DWG. NO.: G2S 4500-PWBO

BUILDING Webster University ISB

CONTRACT NO. 635607 -- Elevator #2 -- Date: 7.20.16

Shop Drawing Submittal Review

HALL FIXTURE DETAIL
① HALL BUTTONS @ ALL FLOORS
② HALL LANTERNS @ FLOOR(S) LL, 1, 2, 3, 4

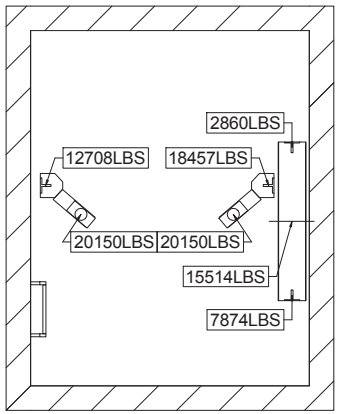
CM/GC COORDINATE TO LOCATE BUTTONS AND LANTERNS PER 17/A0551 AND SHEET EG 111. LOCATE IN FURRING PARTITION PER 15/A0551.

HALL FIXTURE DETAIL

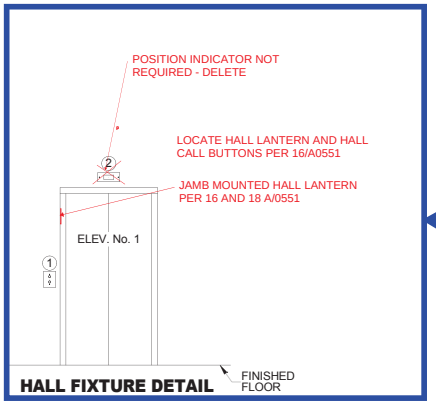
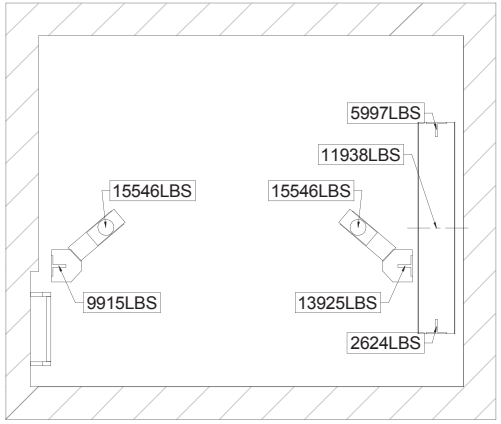
LADDER AND POCKET DETAIL
ELEV. No. 1
RECESS NOT NEEDED FOR LADDER

SUMP PITS TO BE INSTALLED PER 1/2 - A0551

PREVIOUS MARKUP FOR REFERENCE
